Our Ref: 21/01483/SDR

**STREET DESIGN REVIEW SERVICE - 21/01483/SDR
DEMOLITION OF EXISTING SCHOOL, DESIGN AND BUILD OF NEW SCHOOL INCLUDING
DROP-OFF AND PARKING. PROVISION OF 15NO UNITS OF AFFORDABLE HOUSING AT
DUNVEGAN PRIMARY SCHOOL, COLBOST, DUNVEGAN, ISLE OF SKYE, IV55 8GU**

Reference no:	21/01483/SDR	Date of Issue:	████████████████████
Proposal:	Demolition of existing school, design and build of new school including drop-off and parking. Provision of 15no units of affordable housing	Address:	Dunvegan Primary School Colbost Dunvegan Isle of Skye IV55 8GU
Case officer:	PREMAJ Application	Email and phone no:	majorpreapps@highland.gov.uk
Confidentiality Requested

Layout of School tables for discussion (extract from drawing 912_021 Rev E dated 29/04/21).

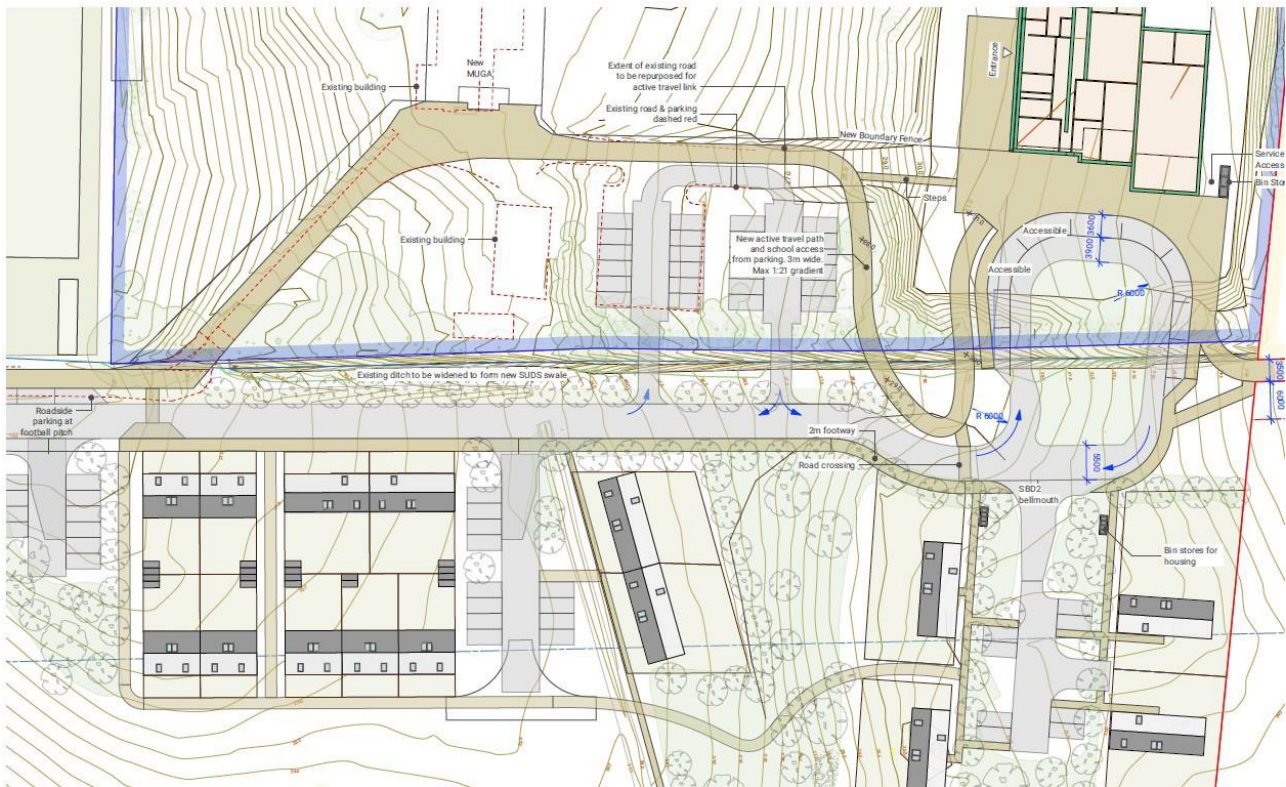
1. Walking Wheeling and Cycling Route to the School

THC asked for alternative layout of routes to be considered to include:

- Main active travel route adjacent to new road
- The accessible route made attractive for all users – don't segregate users.
- Designing out steps (or at least make them secondary -if it is necessary to retain make them generous – current proposals appear too narrow).
- Raised tables where route crosses vehicular accesses. Minimise these conflict points.

2. School Buses and Taxis Pick Up / Drop Off

Transport Statement to address safety aspects (reversing a hazard hence desire for turning circle or looped access). THC asked for alternative layout of route to be considered to include

- Use existing vehicular access route, provide drop off on this loop and continue with exit onto new road.

- b) Not mentioned at workshop but consideration could be given to drop off on footway of new road in front of school with turning loop for road beyond this and not in school grounds.

3. School Servicing

Reversing is a safety hazard. Waste collection and kitchen servicing need servicing with large vehicles. Not practical to use loop due to level difference and requirement for deliveries. THC asked for alternative servicing layout to be considered to include:

- a) Servicing via short section of reversing from a turning facility (turning head or circle) for the new public road. Children to be segregated from the access area required for reversing.

4. School Pick Up and Drop Off

Transport Statement required to inform the number of spaces required for pick up and drop off. THC asked for alternative layouts to be considered to include:

- a) Use of existing vehicular access route with looped route exiting onto new road.
- b) If parents are using drop off laybys on the new road where will they turn? Are there safety implications?
- c) Conflict with residents shall be considered and minimised in the design.
- d) Parking for nursery school rather than drop off, these children are escorted to the classroom. Route from parking area to entrance should be accessible / suitable for buggies.

5. School Parking and Parking for the Pitch

- a) Transport statement required to inform the number of spaces required.
- b) As noted above nursery drop off requires parking and an accessible route to the school entrance.
- c) All parking requires an active travel route to the school entrance.
- d) As noted above the conflict of entrance /exits with main active travel route should be minimised. The interaction with school transport should be considered (and minimised with priority given to school transport if practicable and safe).
- e) Consideration to be given to parking for the pitch; how it will be managed (will it conflict with the school pick up and drop off?) This includes some disabled persons parking.

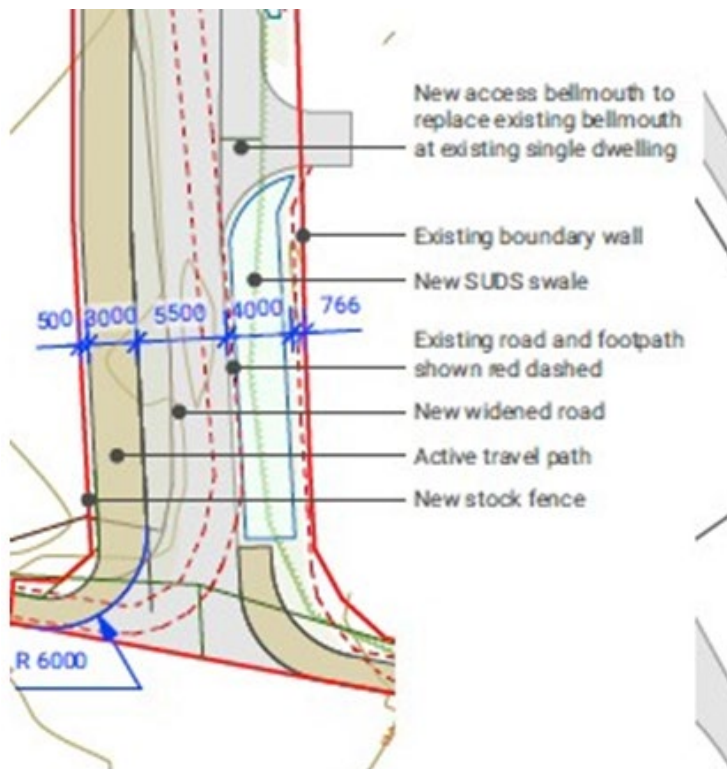
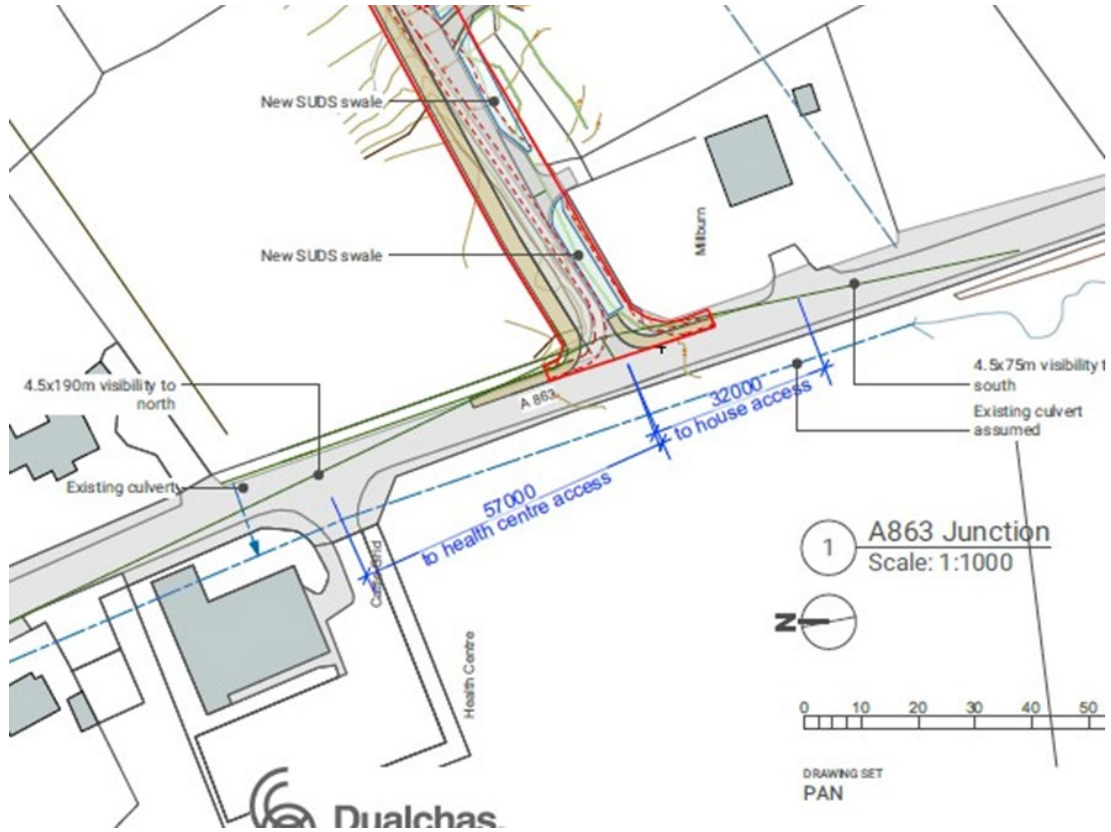
6. Housing Block Structure and Street Design

THC requested alternative layouts to be considered to include

- a) Redesign of the block so that parking against the gable end is not the first impression of the new residential development.
- b) Active gable end and provision of courtyard parking.

- c) Sketch from Matthew attached below showing some possibilities.
- d) Parking areas and the turning heads at the end are not likely to be adopted so refuse collection will be required from the proposed new road. The design team confirmed that these turning heads are required for emergency access as it is too far for the fire engines to reverse. In developing the housing layout its relation to the public road and the routes from the houses to the road needs to be considered. Details of where and how the bins will be stored and collected are required. Given the concentration of housing without direct frontage onto the road appropriate hardstanding space to store the bins for kerbside collection with reasonable carry distances and that do not block visibility /cause amenity issues are required.

- e) Notwithstanding the above there is a need to ensure that there is meaningful amenity space for the properties as well as parking and road.
- f) As a general point regarding the road design; the boundary between the public road and the private school land/development should be clearly defined.
